Brunswick County Courthouse Addition & Renovations

Addendum 3

January 13, 2020

SAWYER SHERWOOD & ASSOCIATE ARCHITECTURE

1 E1.3 ELECTRICAL 1ST FLOOR AUXILIARY SYSTEMS PLAN
SCALE: 1/8" = 1'-0"

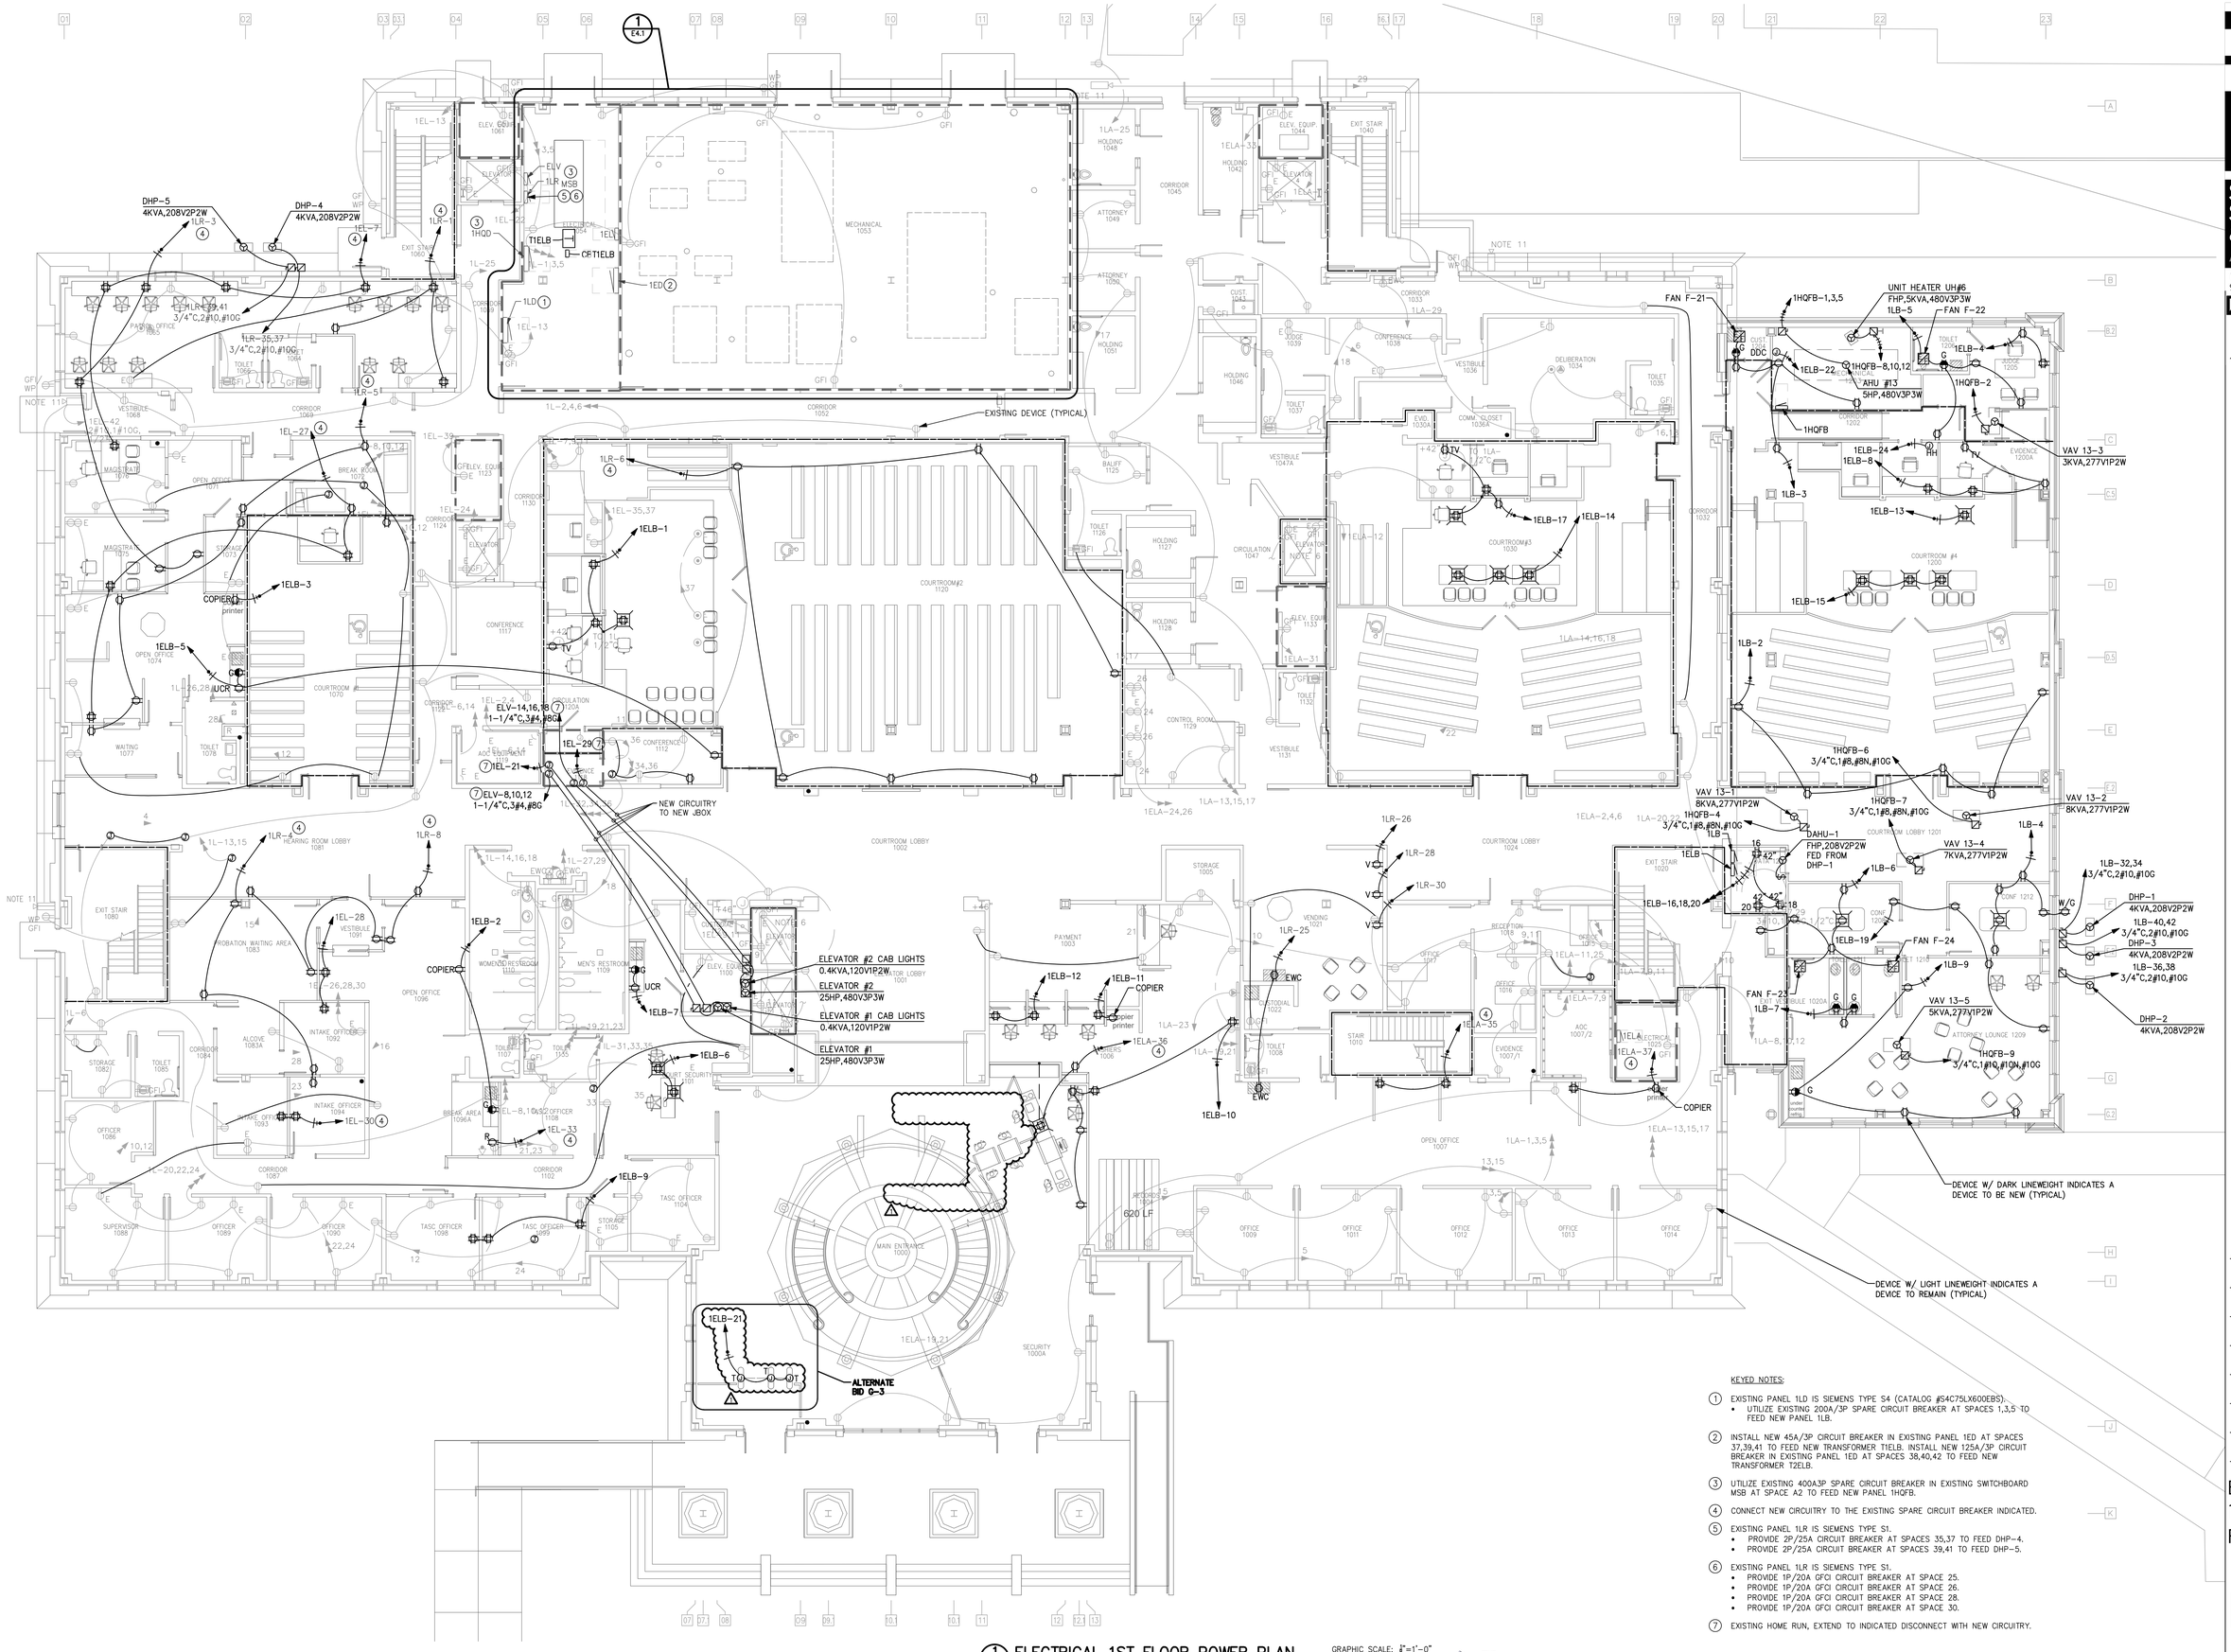
37. Sheet E1.3 is reissued and enclosed with the following clarifications and revisions:
    a. Security 1000 Entrance: Add pull station and horn / strobe.

b. Security 1000 Entrance: Remove data outlet for entrance metal detectors.
    c. Security 1000 Exit: Add pull station and horn / strobe.
    d. Security 1000 Exit: Add fire alarm control module for exit turnstile interface.

e. Security 1000 Exit: Add data outlet for spare future exit turnstile interface.
    f. Elevator Lobby 1001: Add horn / strobe.
    g. Courtroom Lobby 1024: Add horn / strobe.

h. Toilet 1064: Add strobe.
    i. Waiting Area 1077: Change strobe to horn / strobe.
    j. Hearing Room Lobby 1081: Add horn / strobes.
    k. Probation Waiting Area 1083: Change strobe to horn / strobe.

l. Corridor 1084: Add horn / strobe.
    m. Court Security 1101: Add horn / strobe.
    n. Courtroom #2 1120: Add horn / strobe.
    o. Attorney Lounge 1209: Change strobe to horn / strobe.

1 E1.5 ELECTRICAL 2ND FLOOR LIGHTING PLAN
SCALE: 1/8" = 1'-0"

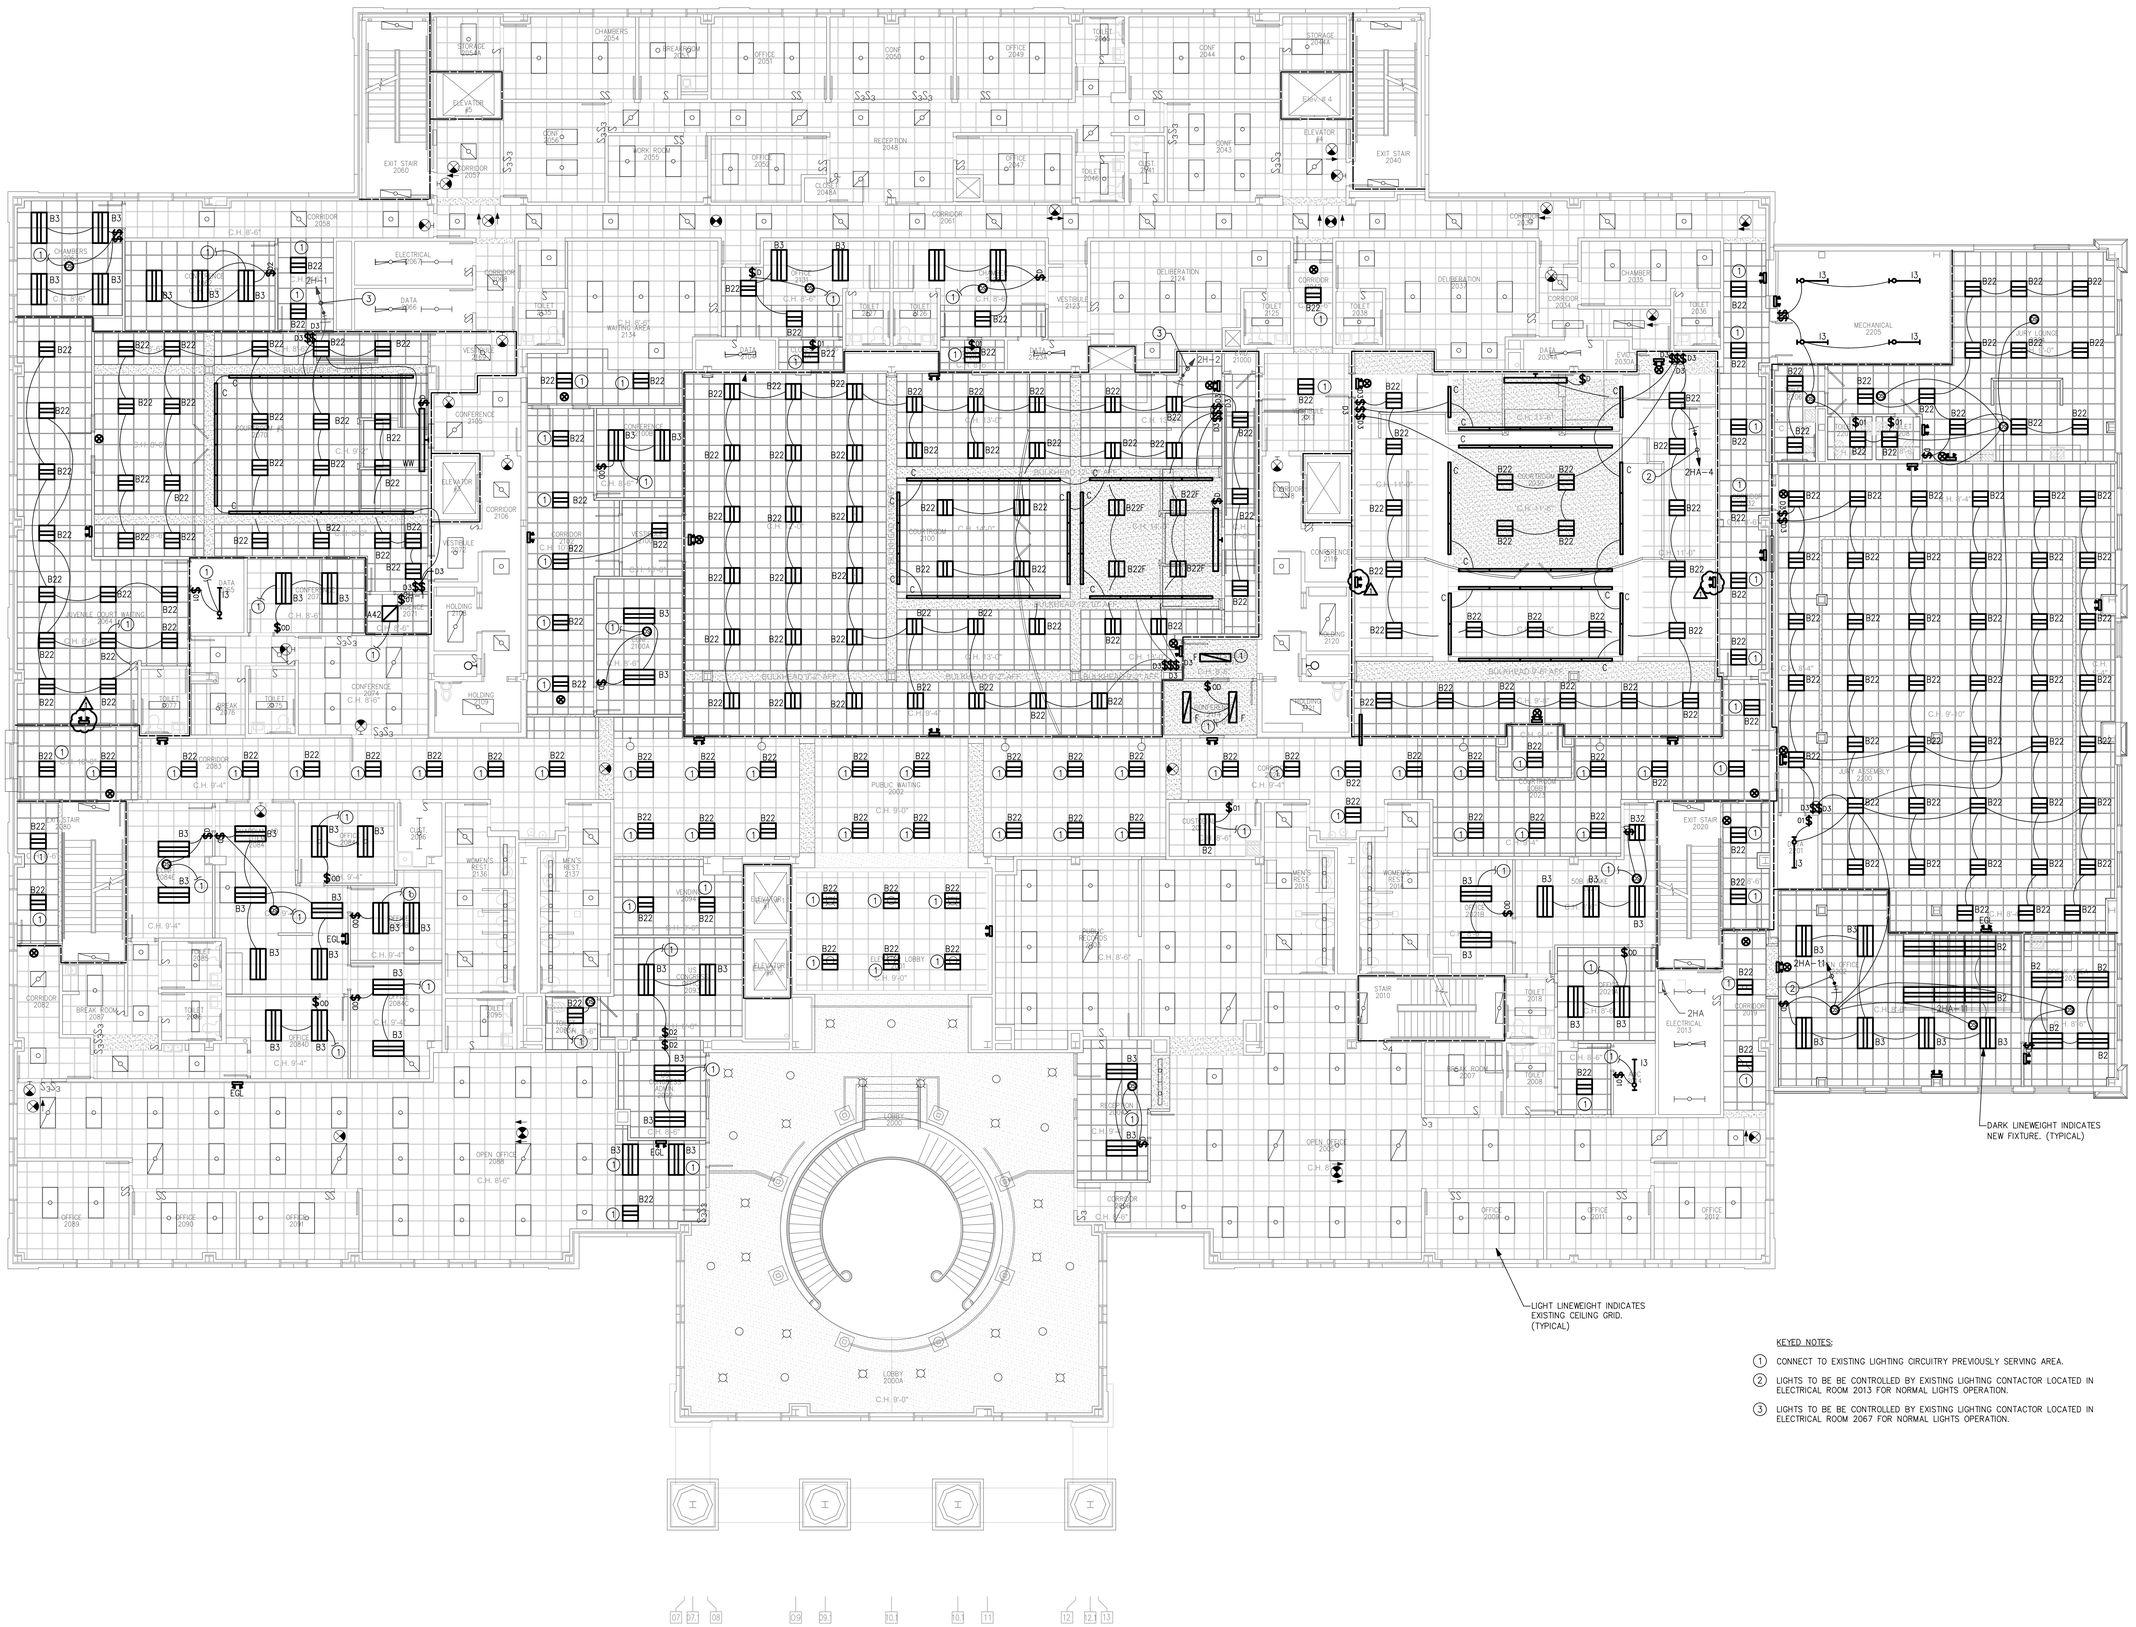
38. Sheet E1.5 is reissued and enclosed with the following revisions:
    a. Courtroom 2030: Add light fixtures type EG.
    b. Juvenile Court Waiting 2064: Add light fixture type EG.

1 E1.6 ELECTRICAL 2ND FLOOR AUXILIARY SYSTEMS PLAN
SCALE: 1/8" = 1'-0"

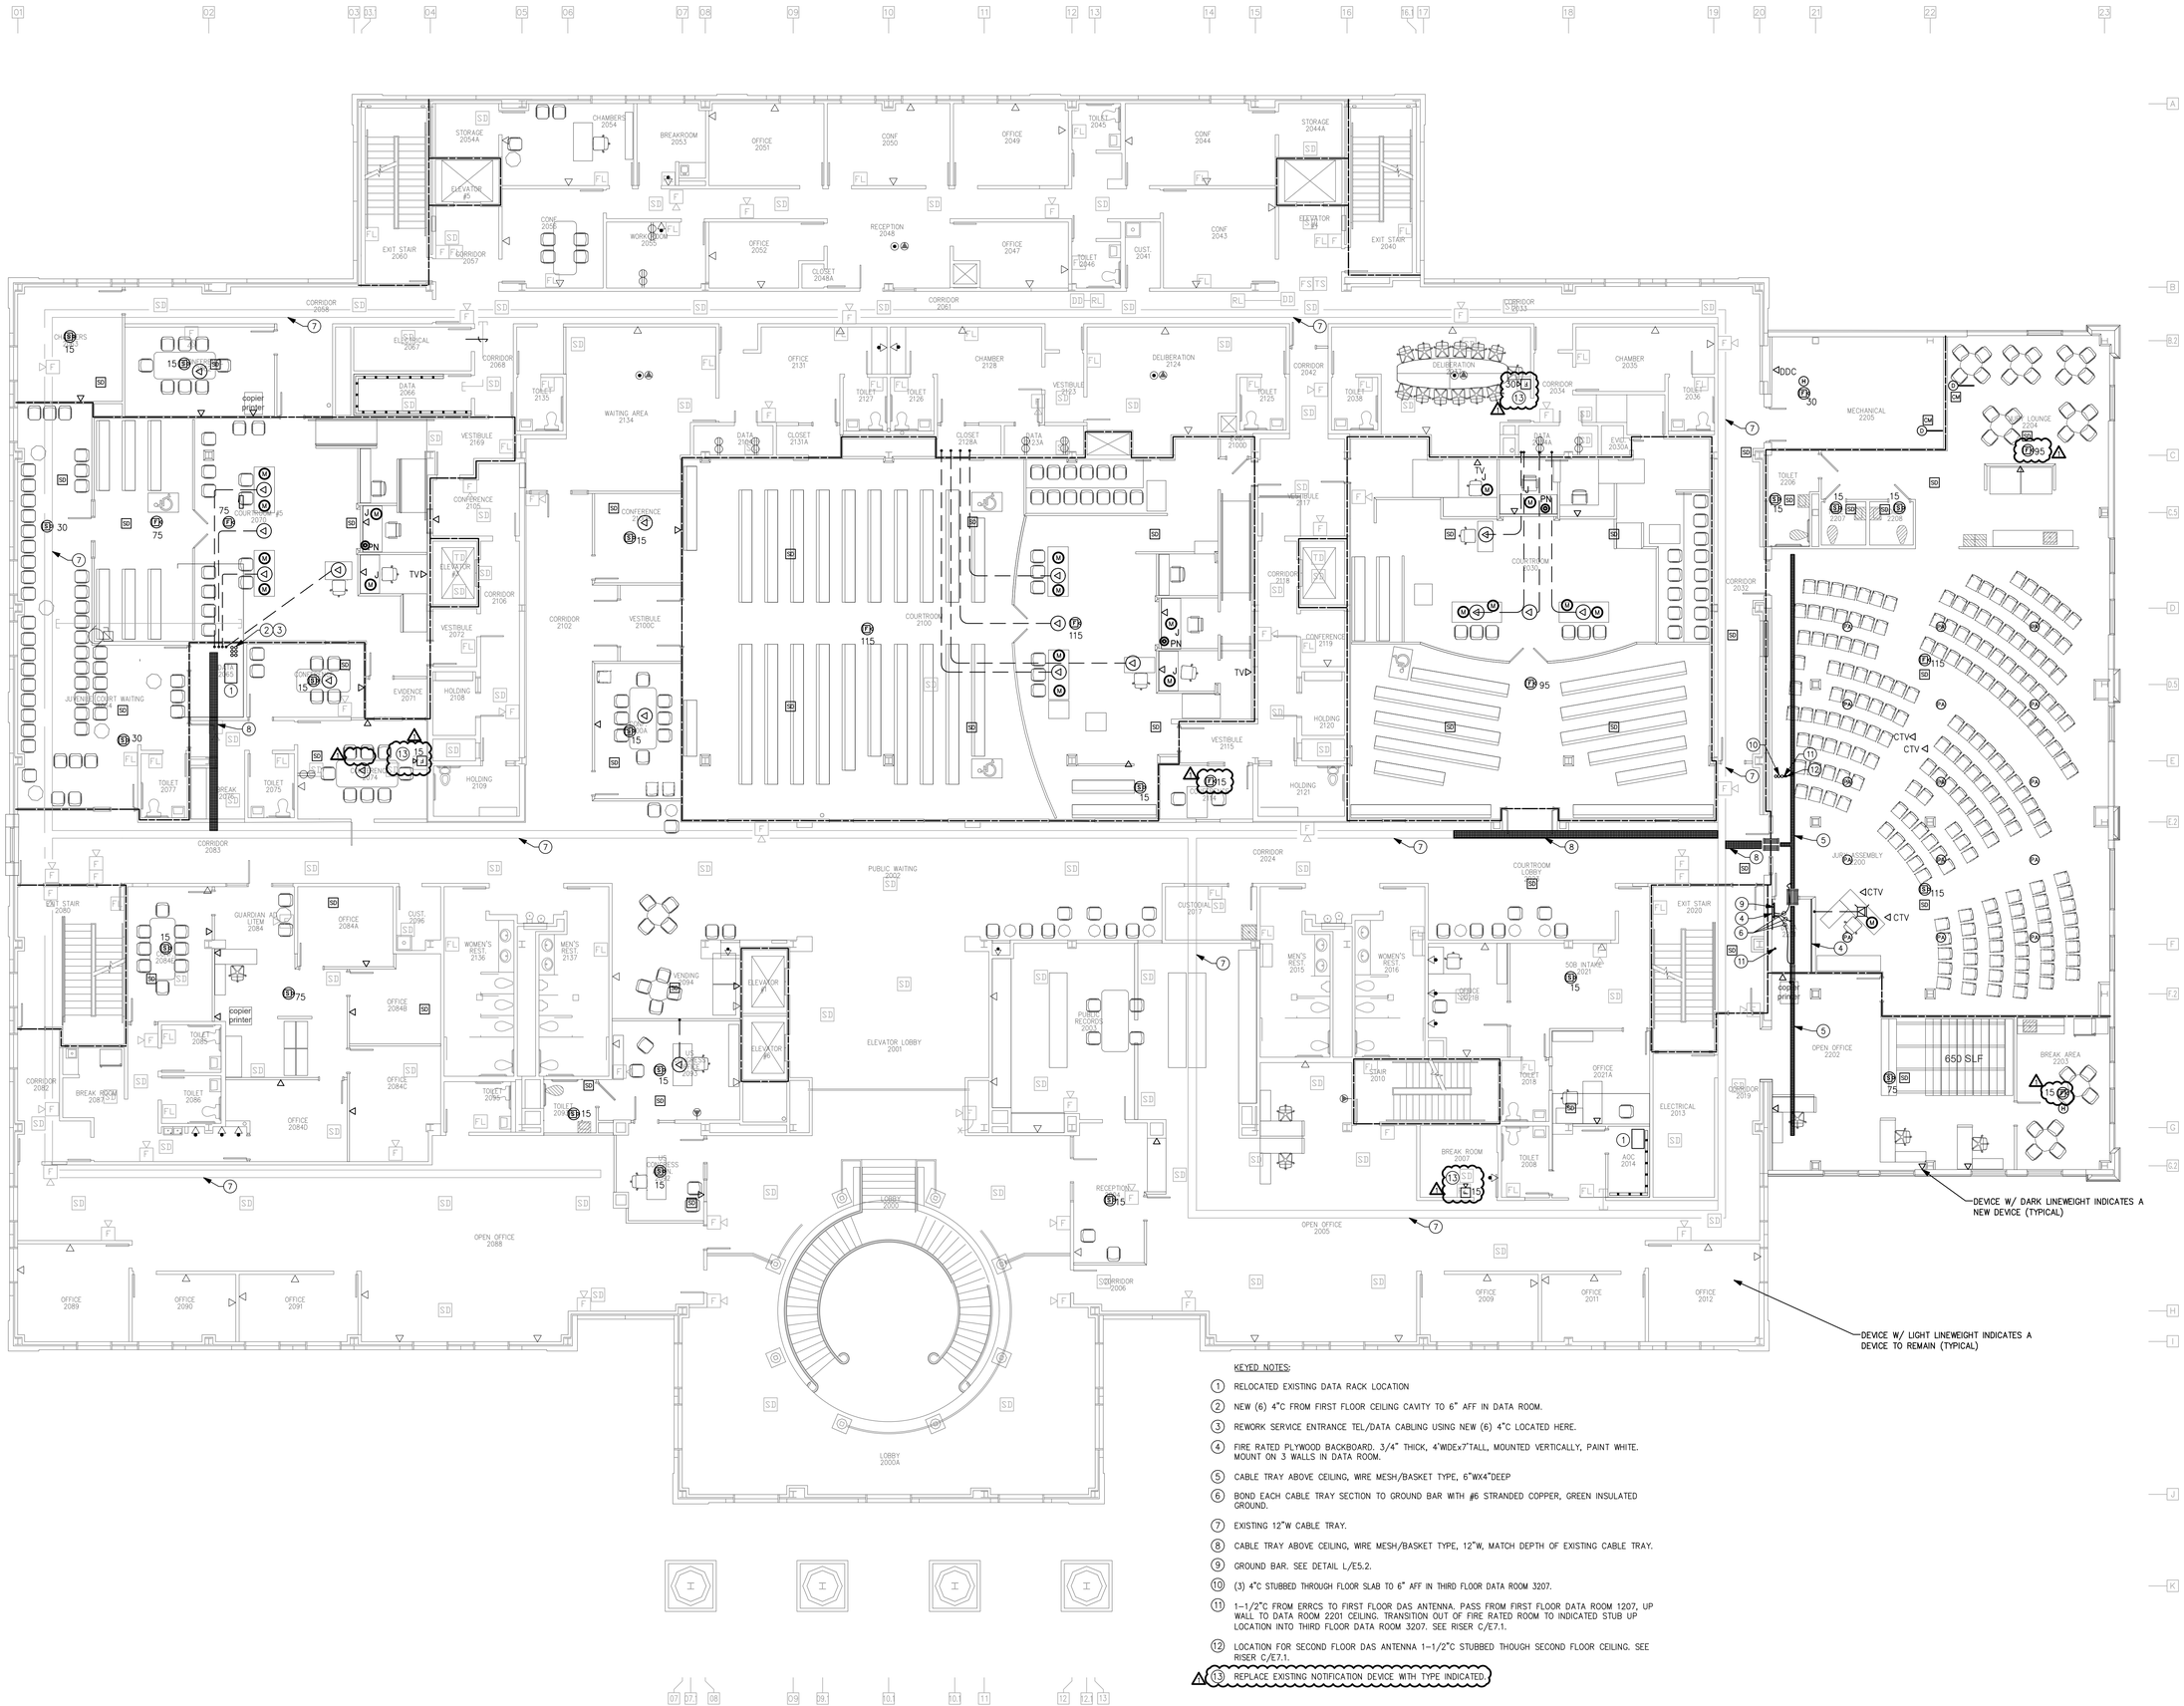
39. Sheet E1.6 is reissued and enclosed with the following revisions:
    a. Break Room 2007: Replace existing strobe with horn / strobe.
    b. Deliberation 2037: Replace existing strobe with horn / strobe.
    c. Conference 2074: Replace existing strobe with horn / strobe.
    d. Conference Room 2114: Add horn / strobe.
    e. Break Room 2203: Change strobe to horn / strobe.
    f. Jury Lounge 2204: Change strobe to horn / strobe.
